**CITY PLAN COMMISSION****THURSDAY, JUNE 26, 2025****FILE NUMBER:** S245-123R**SENIOR PLANNER:** Hema Sharma**LOCATION:** South Boulevard at Gould Street, west corner**DATE FILED:** May 29, 2025**ZONING:** PD 595 (FWMU-3)**PD LINK:** <https://dallascityhall.com/departments/city-attorney/Articles/PDF/Article%20595.pdf>**CITY COUNCIL DISTRICT:** 7**SIZE OF REQUEST:** 0.543-acres**APPLICANT/OWNER:** Bruce Kaminski, Kaminski Custom Builders, LLC

**REQUEST:** An application to revise a previously approved preliminary plat (S245-123) to replat a 0.543-acre tract of land containing all of Lots 39, 40 and 41 in City Block 5/1116 to create one lot on property located on South Boulevard at Gould Street, west corner.

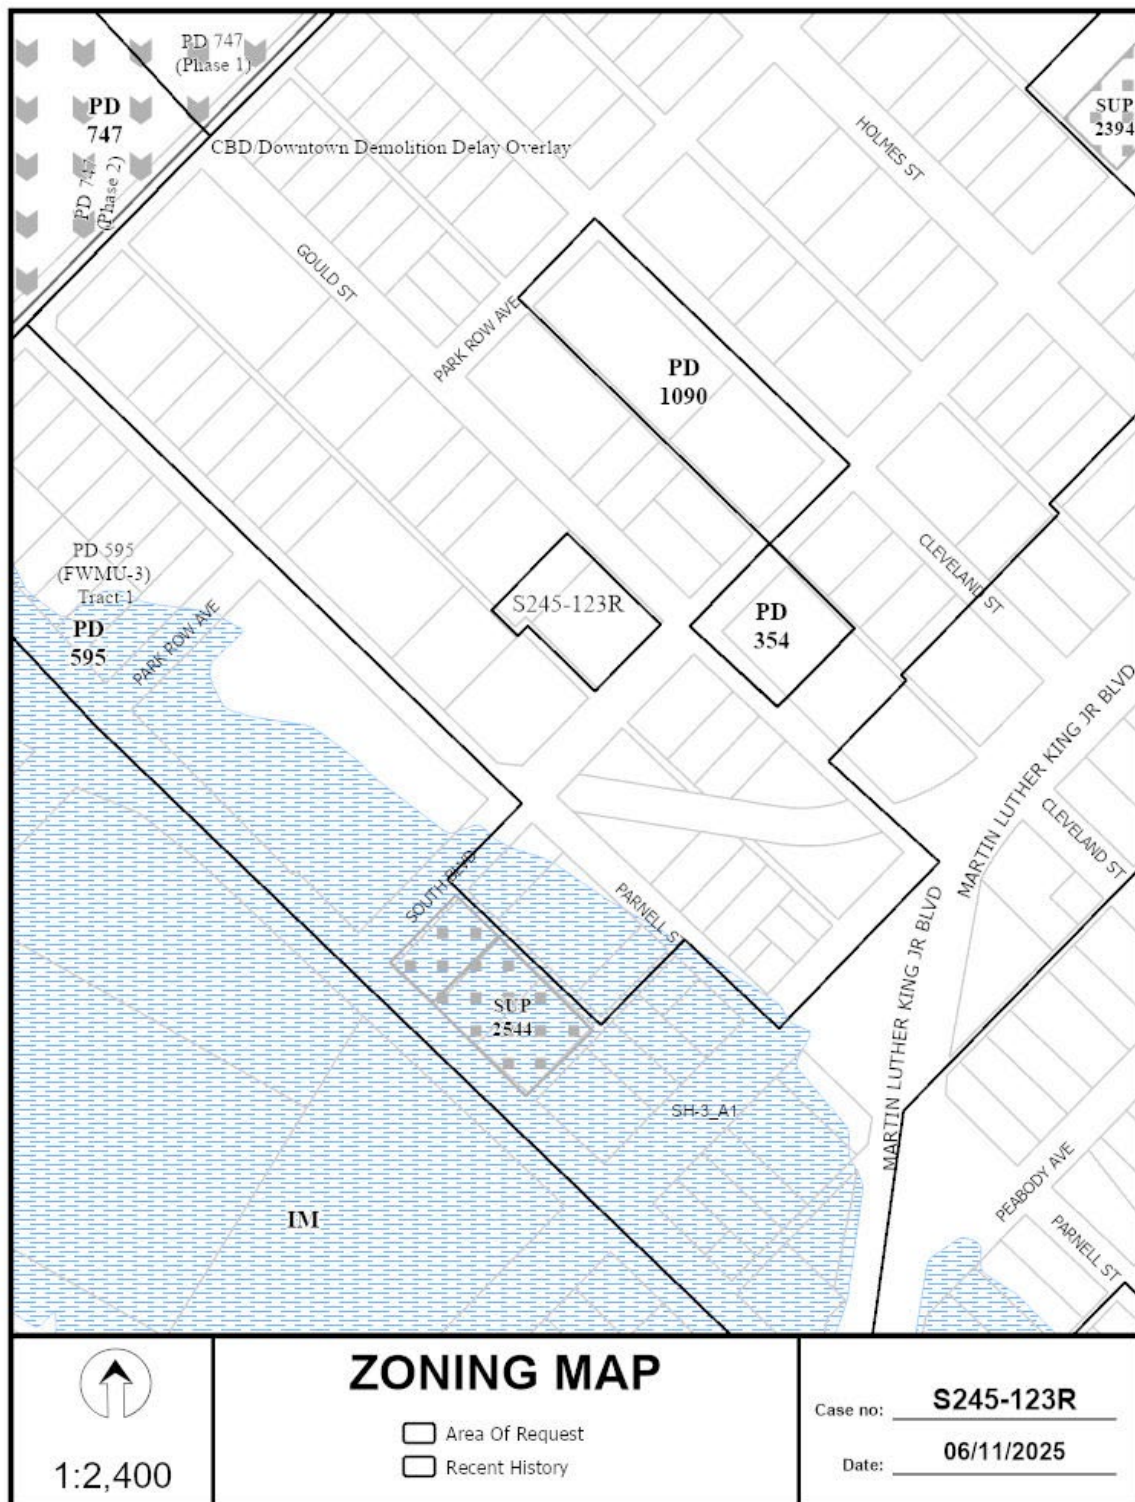
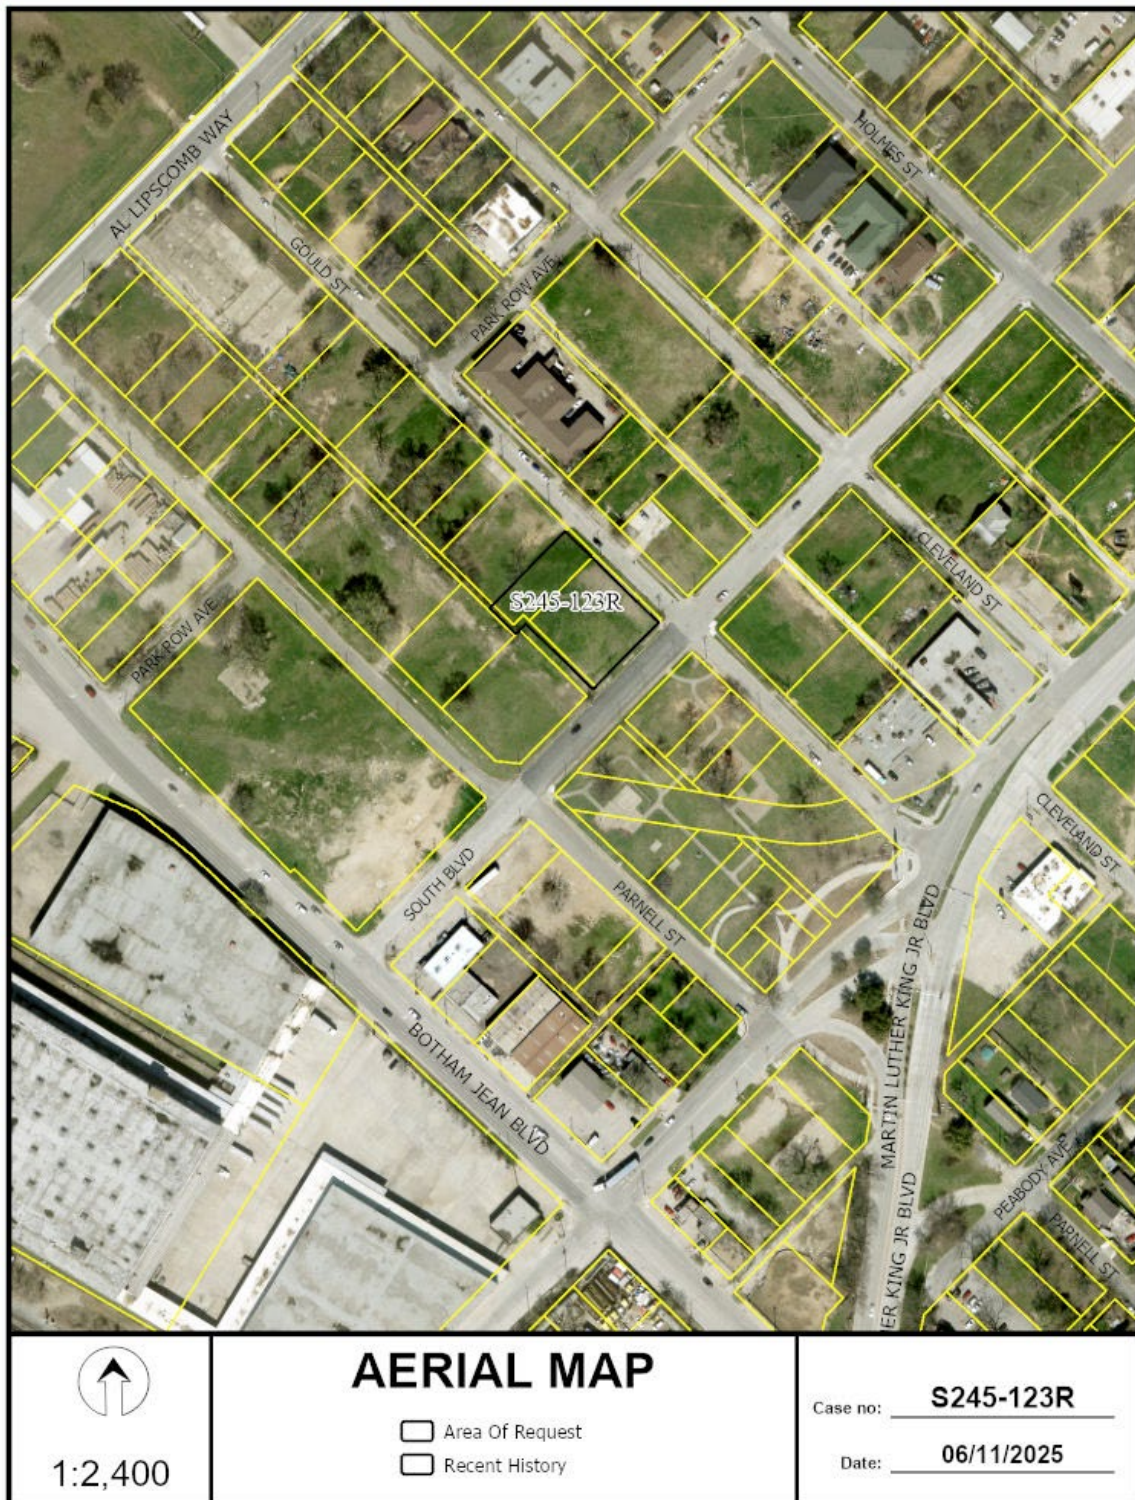
**STAFF RECOMMENDATION:** The request complies with the requirements of PD 595 (FWMU-3); therefore, staff recommends approval of the request subject to compliance with the following conditions:

5. Any new or existing structure may not extend across new property lines. *Section 51A-8.503(e)*
6. On the final plat, all easement abandonments, and ROW abandonments must be by separate instrument with the recording information shown on the face of the plat. A release from the Real Estate Division is required prior to the plat being submitted to the Chairman for signature.

11. The number of lots permitted by this plat is one.

16. On the final plat, dedicate 7.5 feet of right-of-way (via fee simple) from the established center line of Alley. *Section 51A 8.602(c)*
17. On the final plat, dedicate 28 feet of right-of-way (via fee simple or street easement) from the established centerline of Gould Street. *Sections 51A-8.602(c), 51A-8.604(c) and 51A-8.611(c)*.
18. On the final plat, dedicate a minimum 5-foot by 5-foot corner clip (via fee simple or street easement) at the intersection of Gould Street & South Boulevard. *Section 51A 8.602(d)(1)*
19. A larger corner clip may be requested during engineering plan and traffic review to accommodate an adequate turning radius, or to maintain public/traffic

20. On the final plat, dedicate a 15-foot by 15-foot Alley Sight Easement at the intersection of South Boulevard & the alley. *Section 51A-8.602(e)*
21. Must coordinate with Transportation Department for any traffic signal requirements that are deemed necessary for improving pedestrian accessibility and safety related to site development (Contact Srinivasa Veeramallu with Traffic Signals). *51A-8.606, 51A-8.608*

22. Prior to final plat, submit a completed final plat checklist and all supporting documents.
23. Prior to final plat, clarify alley maneuverability.

24. Additional design information is required for assessment. Site plan must be submitted showing proposed development, building finished floor elevation, development, existing mains – including downstream manhole, and proposed water and wastewater service locations. Submit water/wastewater engineering plans to 320 E. Jefferson Blvd., Room 200, Attention: Water and Wastewater Engineering.
25. Water and Wastewater main improvements may be required by Private Development Contract. Submit water/wastewater engineering plans to 320 E. Jefferson Blvd., Room 200, Attention: Water and Wastewater Engineering.

26. Prior to final plat, compliance with City's street lighting standards including illumination standards, material, installation, and activation per Street Design Manual.
27. Pedestrian passage required per Sec.51A-13.502(a) & (b) (7)
28. On the final plat, identify the property as Lot 39A in City Block 5/1116.
